CITY OF HOPEWELL

Hopewell Regional Wastewater Treatment Facility Alternative 4A-1 Light Phase 2 Improvements

Results of Value Engineering Concepts Evaluation

APRIL 30, 2014

**SEGREGATED MBBR SYSTEM
UPPER PLAN 1 OF 2**

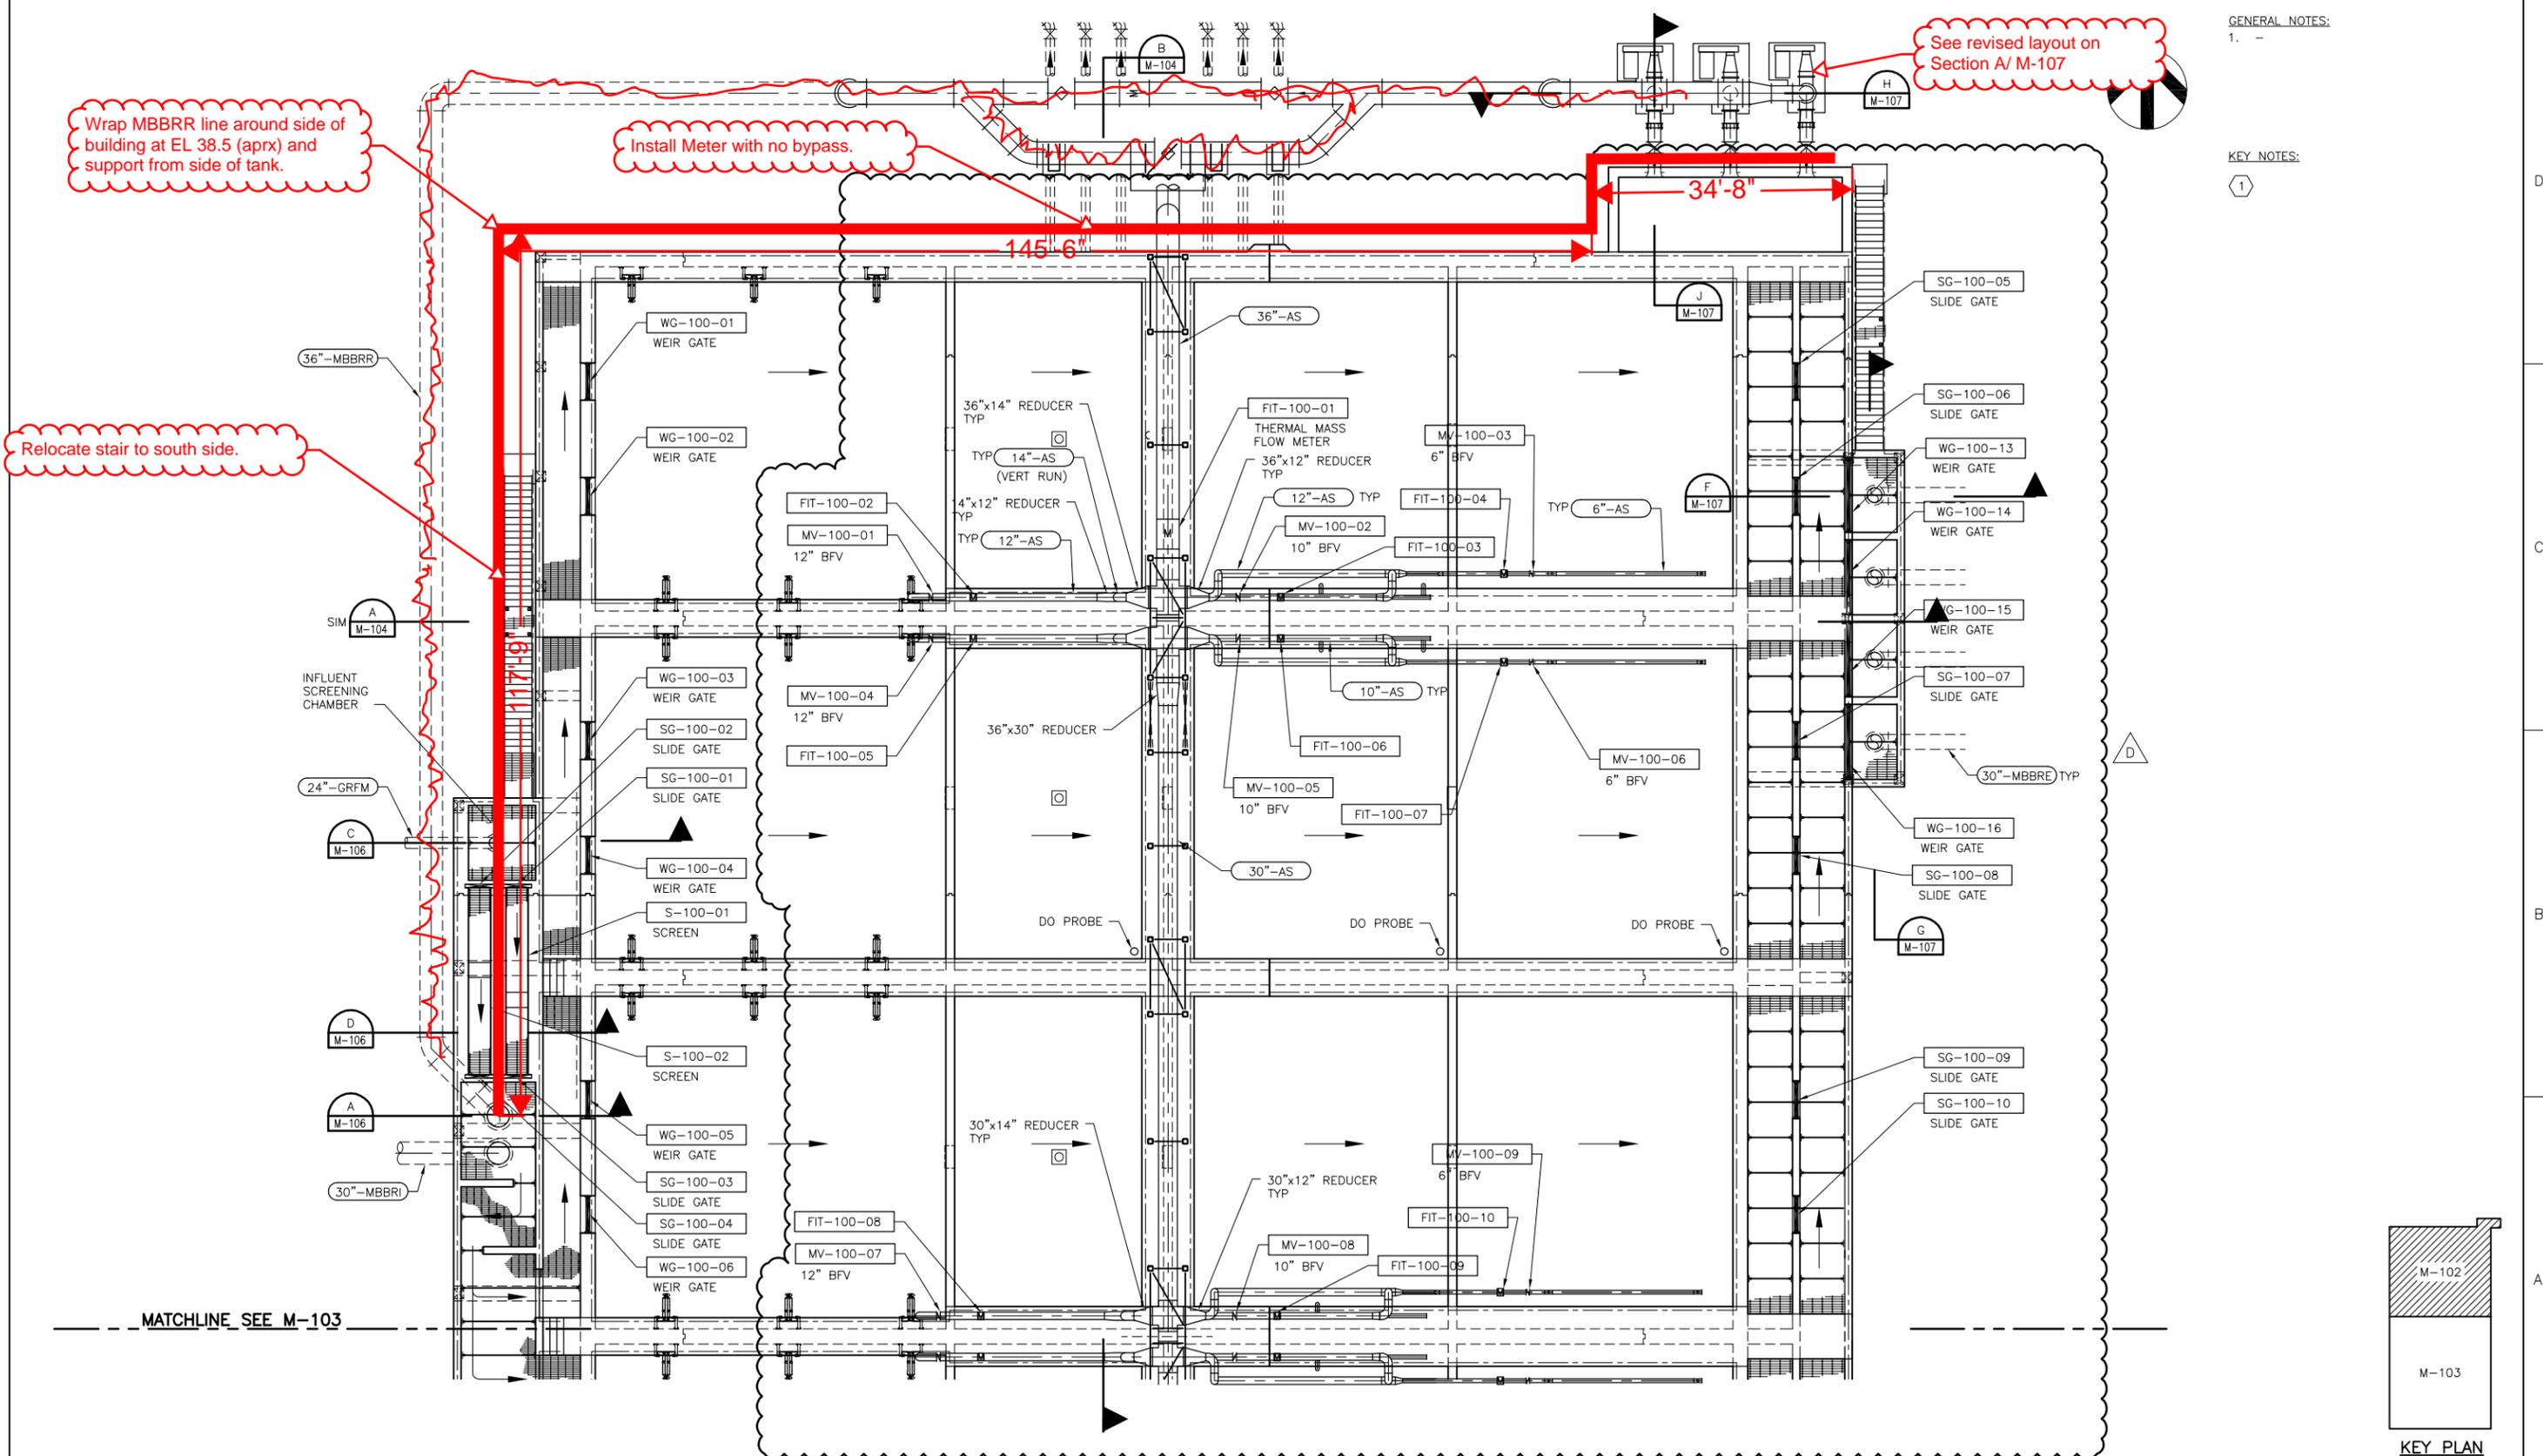
See revised layout on Section A/ M-107

Wrap MBBRR line around side of building at EL 38.5 (aprx) and support from side of tank.

Install Meter with no bypass.

Relocate stair to south side.

SEGREGATED MBBR SYSTEM SECTIONS

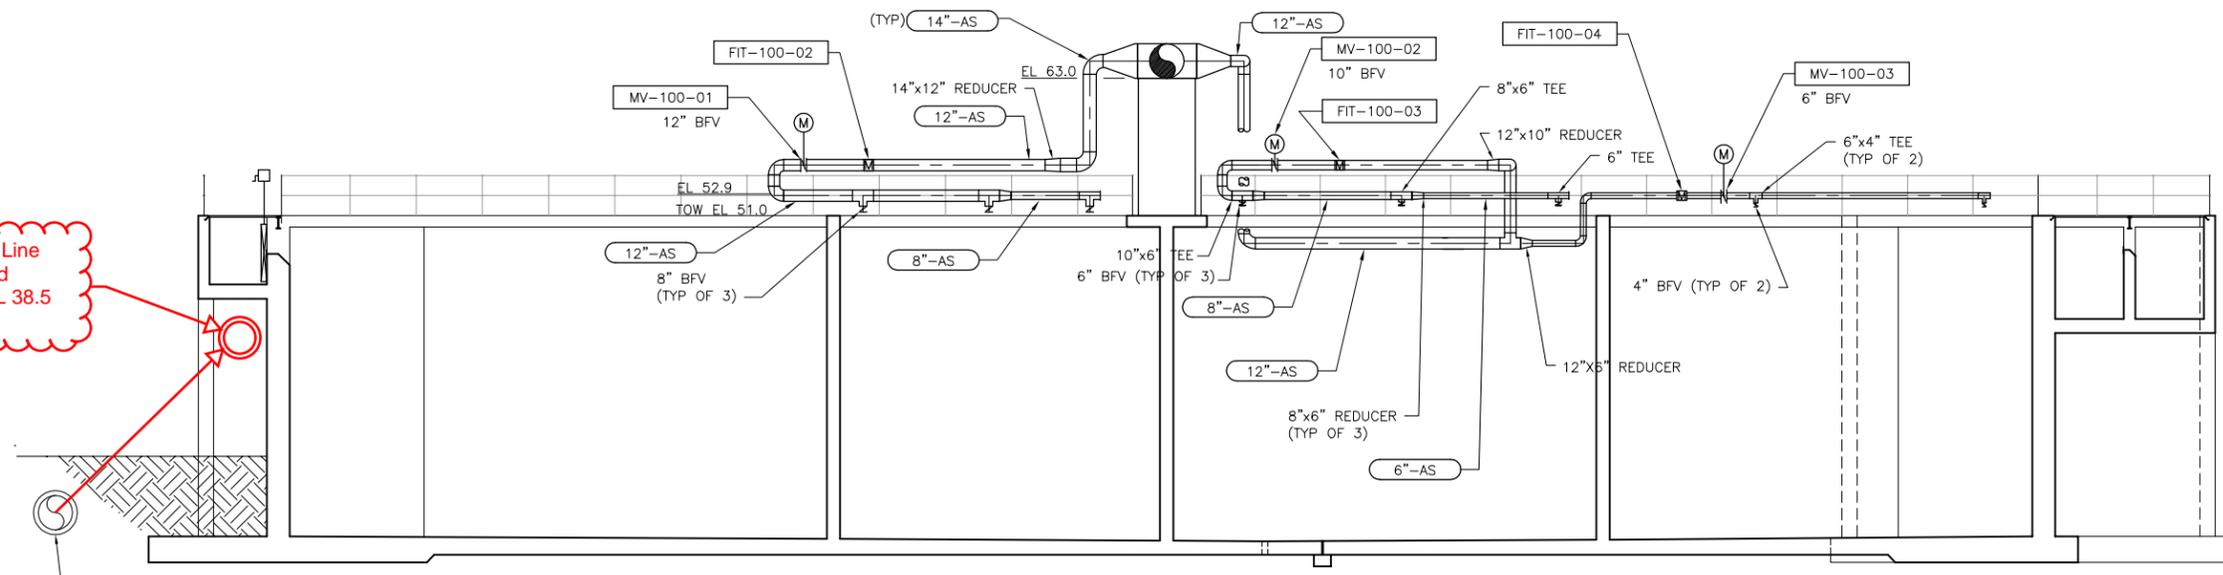
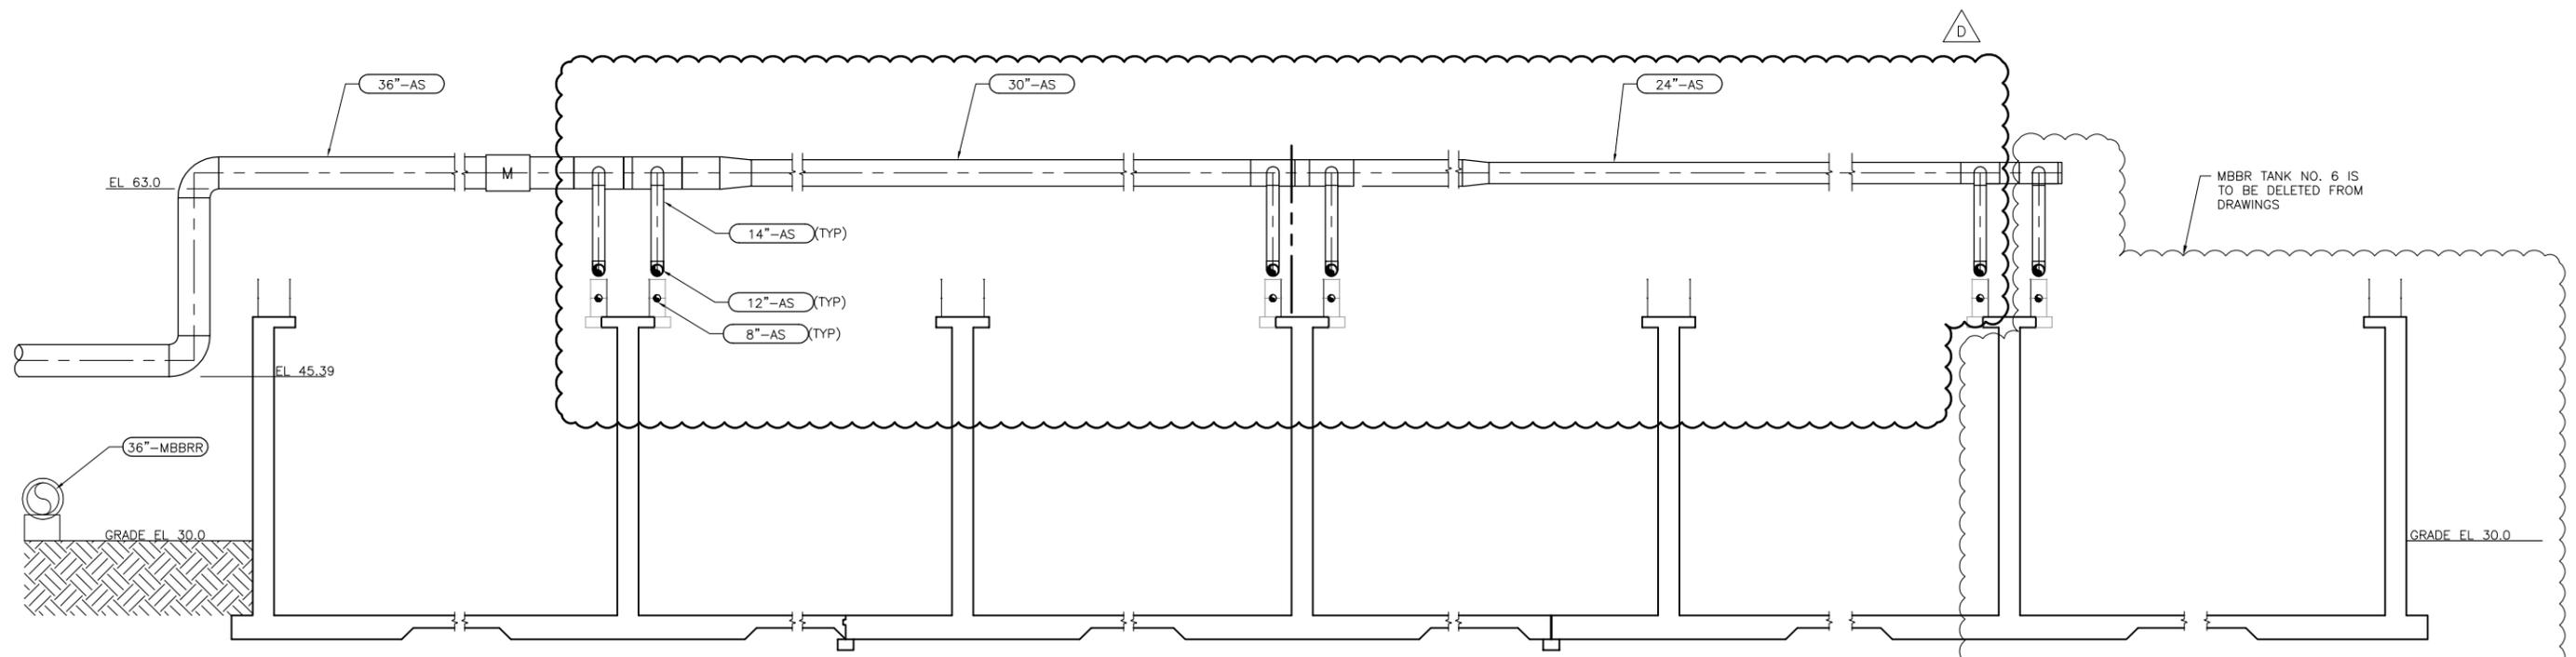
Route MBBRR Line exposed around MBBR at CL EL 38.5 (aprx)

**SEGREGATED MBBR SYSTEM
SECTIONS AND DETAILS**

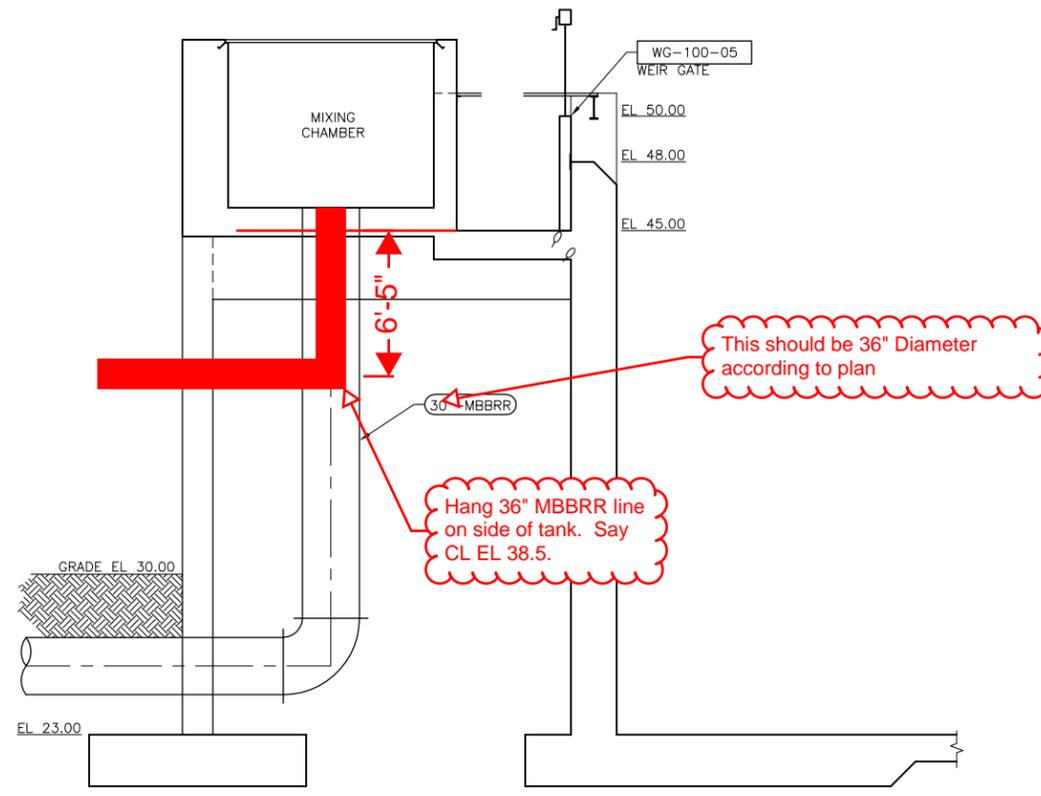
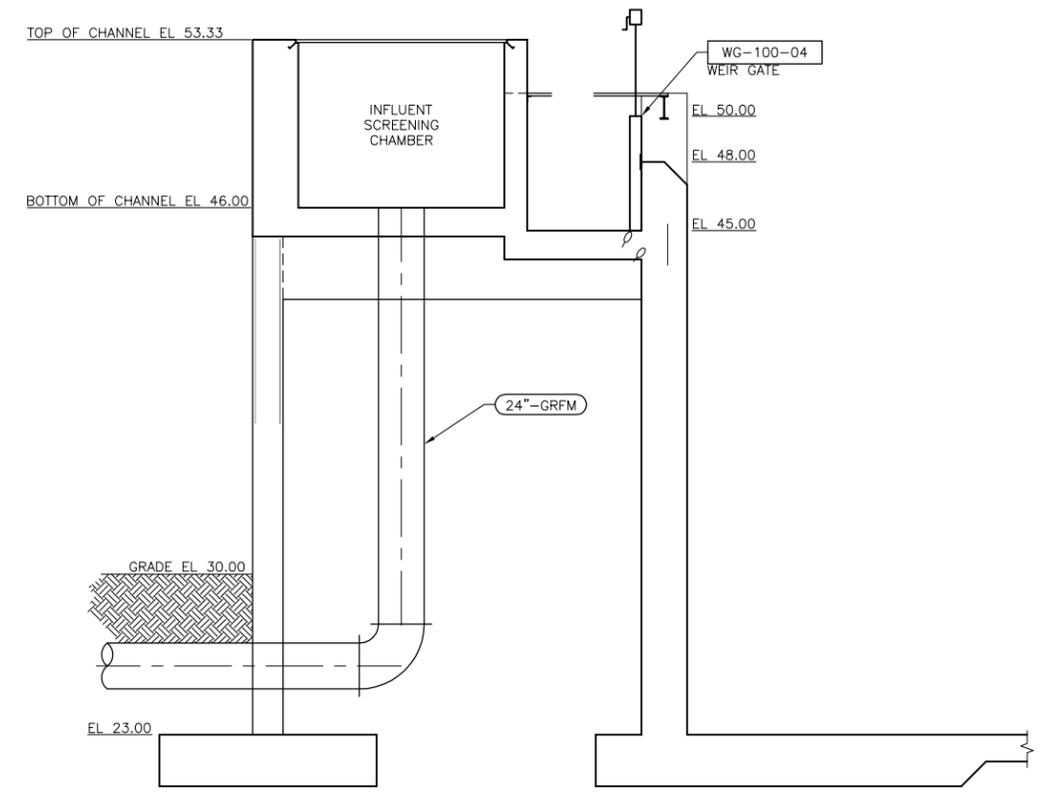
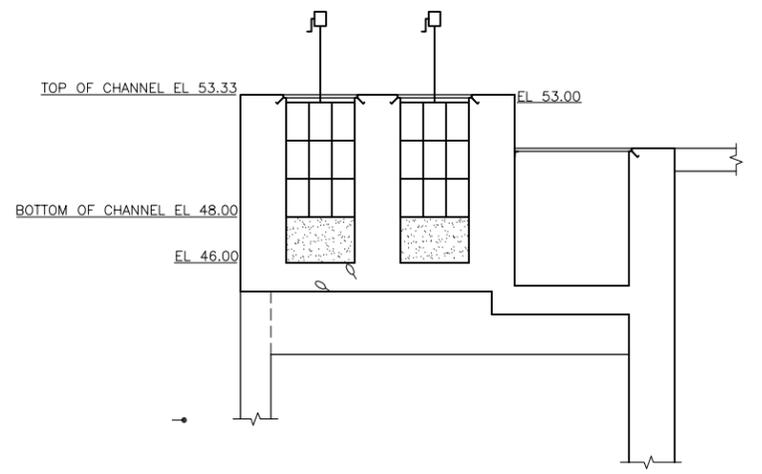
This should be 36" Diameter according to plan

Hang 36" MBBRR line on side of tank. Say CL EL 38.5.

SECTION J
SCALE: 1/4"=1'-0" M-102

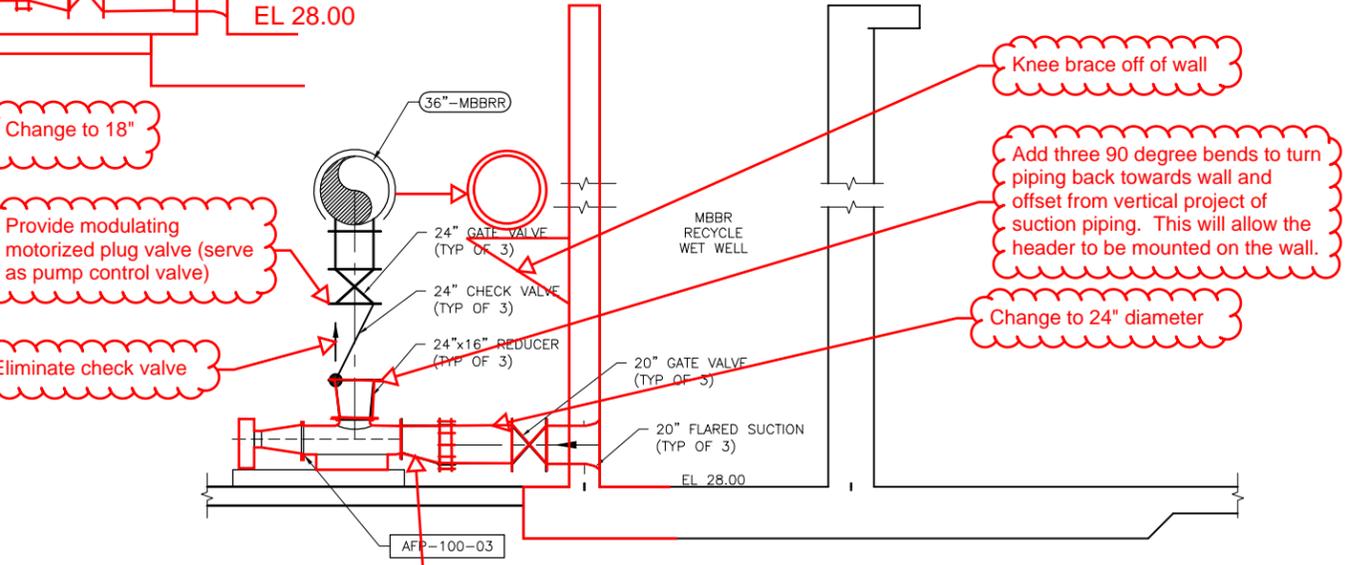
Need section of 16" diameter piping between pump and reducer. Say 5' for estimate.
